MICHIGAN CAT PUMP AND SHORE MAINTENANCE YARD JSP23-47

Consideration of Preliminary Site Plan, Stormwater Management Plan, and Woodland Permit approval at the request of Michigan CAT for an addition of a paved outdoor storage area to the existing Michigan CAT site. The subject property totals 32.39 acres but the affected area is 5.29 acres and is part of an approved PRO. The subject property is located north of Ten Mile Road, on the east side of Novi Road. The approved PRO rezones the portion of the parcel from Light Industrial (I-1) to General Industrial (I-2). The project requires a woodland permit for 47 woodland replacement credits, with 15 replacement proposed to be planted onsite and a donation to the tree fund for the remaining 32 credits.

PLAN REVIEW CENTER REPORT

Review Date: November 8, 2023
Review Type: Combined Preliminary and Final Site Plan Review
Project Name: MI CAT Pump and Shore Maintenance Yard
Location: 24800 Novi Road; 22-23-351-065
Plan Date: October 19, 2023
Prepared by: James Hill, Planner
Contact: E-mail: jhill@cityofnovi.org Phone: 248.347.0547

TREE INVENTORY

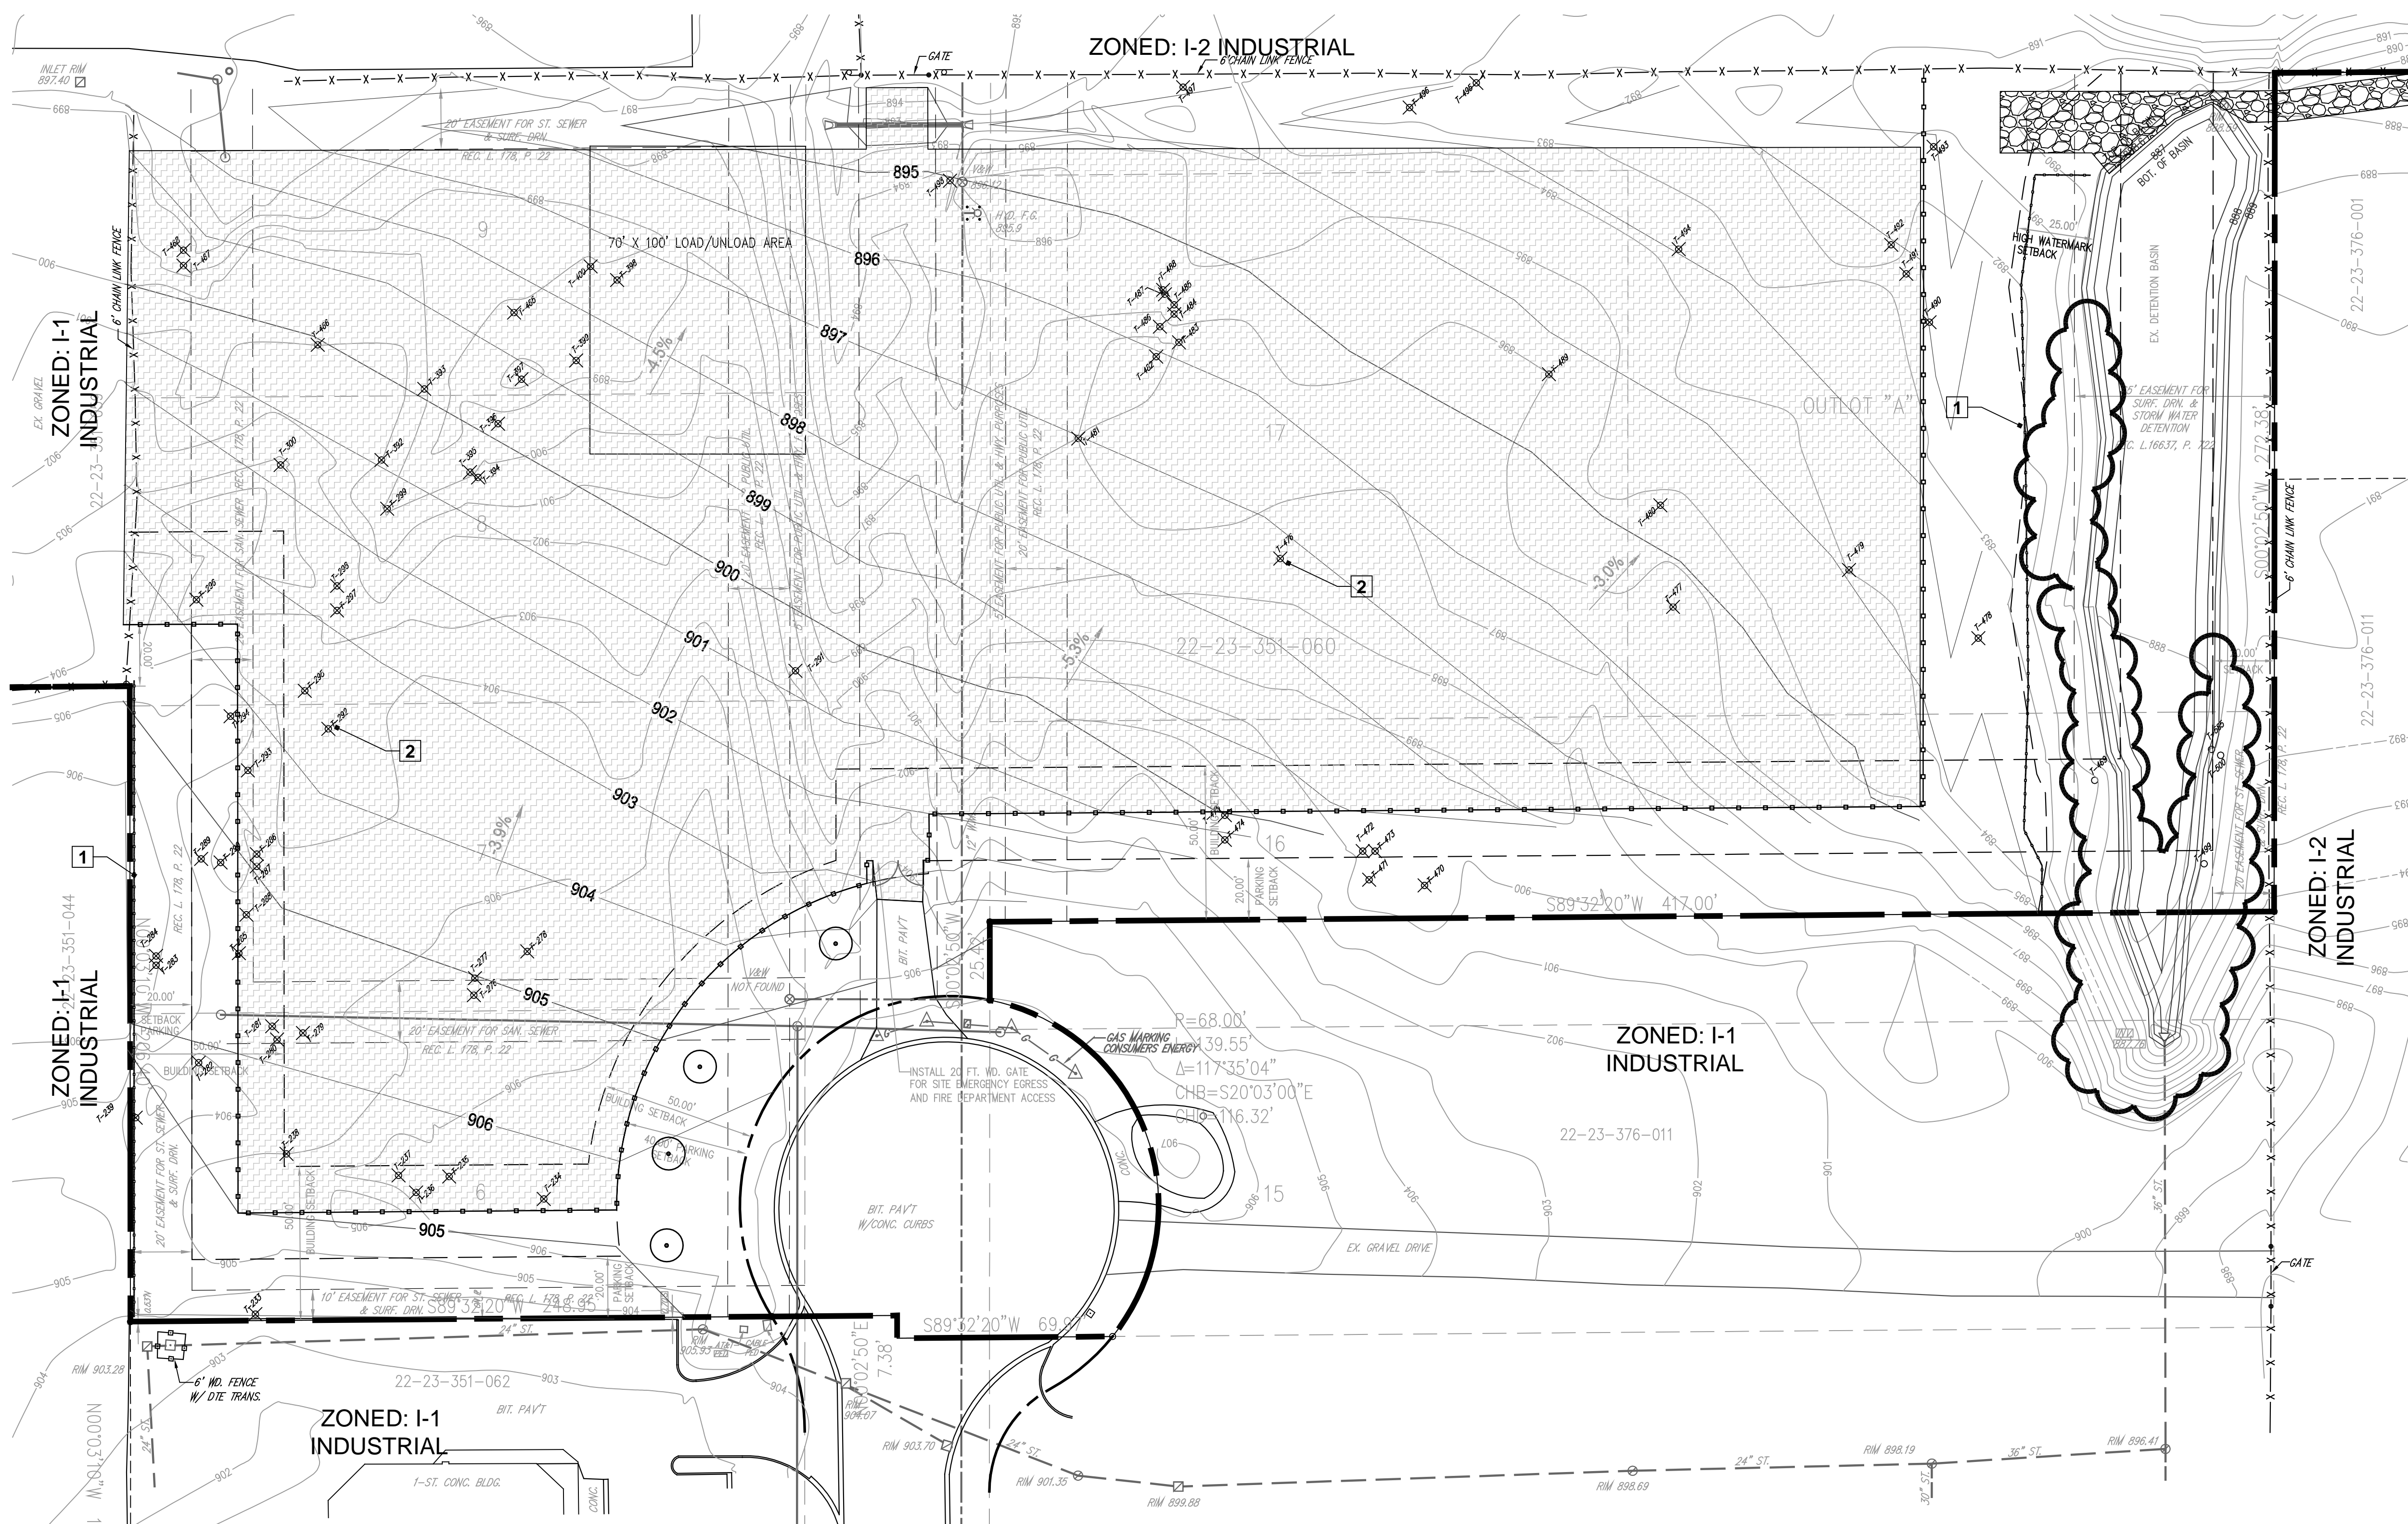
***Note Sheets TL1 incorrectly calculated the tree replacement credits required for multi-stem trees #604 and 606 – see Woodland Review Comment #2 – the total number of replacement credits required is 51 not 47.**

2. **Sheet TL-1. Woodland Replacement Calculations.** The tree replacements calculations for Tree #605 and Tree #606 are incorrect. The required woodland replacement trees for Tree #605 are 8 $((21+24)/8)$ and Tree #606 are 12 $((20+20+17+12)/8)$. The total number of required tree replacements for the site should be 51 not 49. Revise plan sheets.
